UNITED STATES PATENT AND TRADEMARK OFFICE

APPLICATION NO.	FILING DATE	FIRST NAMED INVENTOR	ATTORNEY DOCKET NO.	CONFIRMATION NO.
10/815,948	04/02/2004	Dieter Schwarz	46325	8917

Office Action Summary

DETAILED ACTION

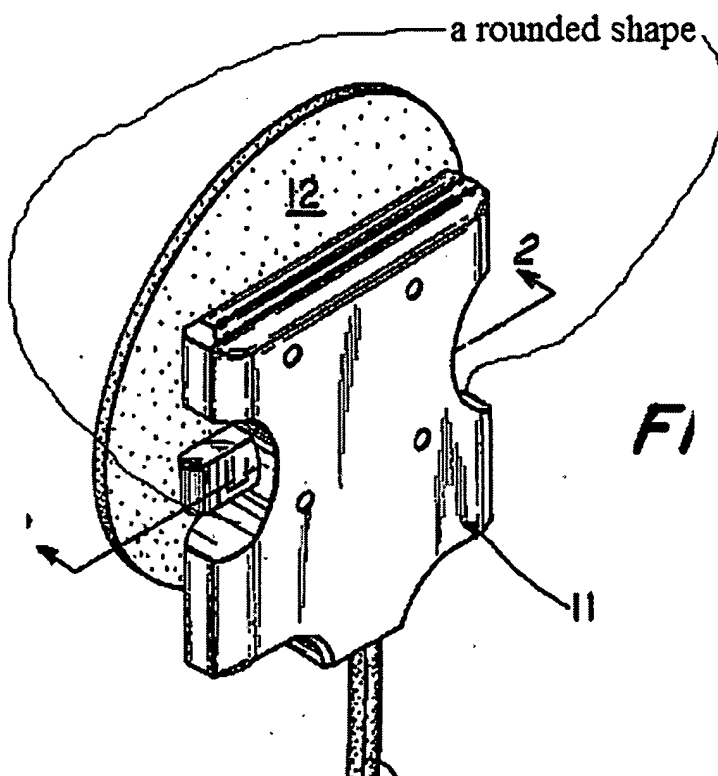
-- In reference to Claim(s) 1, Williams shows (cover sheet)

a housing 11;

a first contact member 21 mounted in the housing for connection to a contact pin 13 of an electrode 12, the contact member 21 having first energy storage element 18 for spring biasing the contact member 21 to engage the contact pin 13; and a first actuating element 15 mounted in the housing 11 to deflect the energy storing element 18 and move the contact member 21 to an open position to receive the contact pin 13.

-- In reference to Claim(s) 2, Williams shows (cover sheet) the electrode is a medical skin electrode.

-- In reference to Claim(s) 10, Williams shows (figure 1) the housing a top with a rounded shape (see examiner's figure).
